## Meeting: 05/26/2020

## COA STAFF REPORT

708 E Second St.

To remove front and back porches. Replace side stoop with patio. Add shutters to front window. Replace side door with window. Replace side window with door as originally located. Remove rear door and east window. Add stoop or awning over front door. Replace current vinyl windows with vinyl windows to match original size.

1897

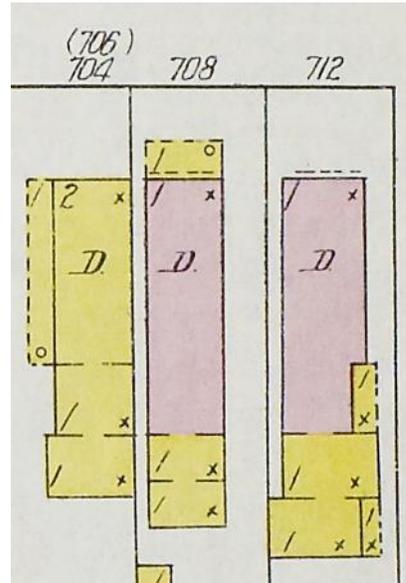
Front porch was removed prior to review. Applicant asked for staff to review removal of the front porch, but staff gave application back to applicant as it did not qualify for staff review or would have been denied due to historic photograph showing a porch. Sanborn maps included on the next page.

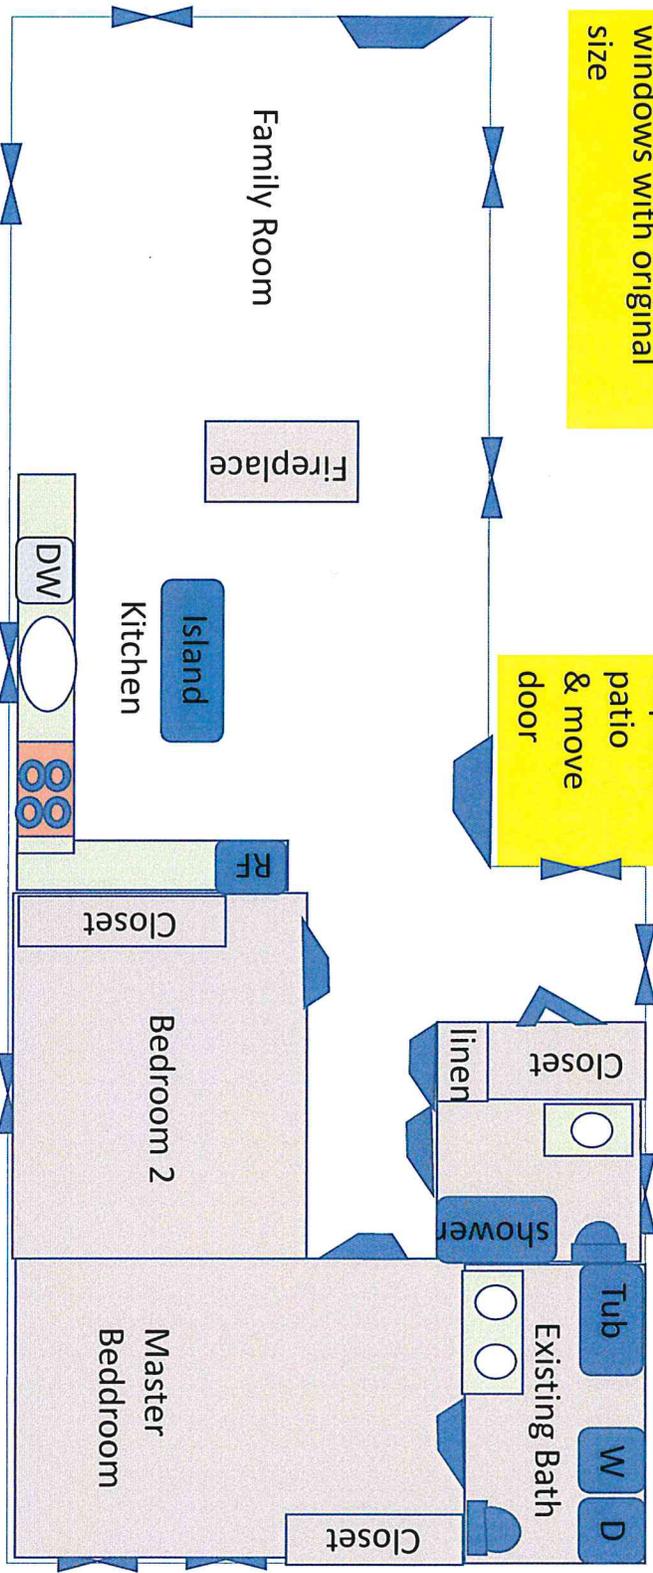
It is staff's opinion that the door project may be in conformance with the design guidelines. Moving a door to its original location based on physical evidence is within the guidelines. The style of door is questionable since the applicant did not provide a brochure of the proposed door. The removal of the front and rear porch is not in conformance with the guidelines. While the front porch does not appear on the 1897 Sanborn map, the rear porch does. The front porch appears on the 1911 Sanborn map. The addition of shutters on the front window may be in conformance with the guidelines if the applicant installs them onto the window frame instead of the wall. All historic evidence of the original shutters were removed with the windows and staff cannot determine from the historic photo provided if the window has shutters. While returning the windows to their original location, except the front window, and their original size is in conformance with the guidelines, the use of vinyl windows visible from the street is not.

Replace all exterior windows with original size

Replace patio & move door

Remove rear patio & door

Remove patio & replace window
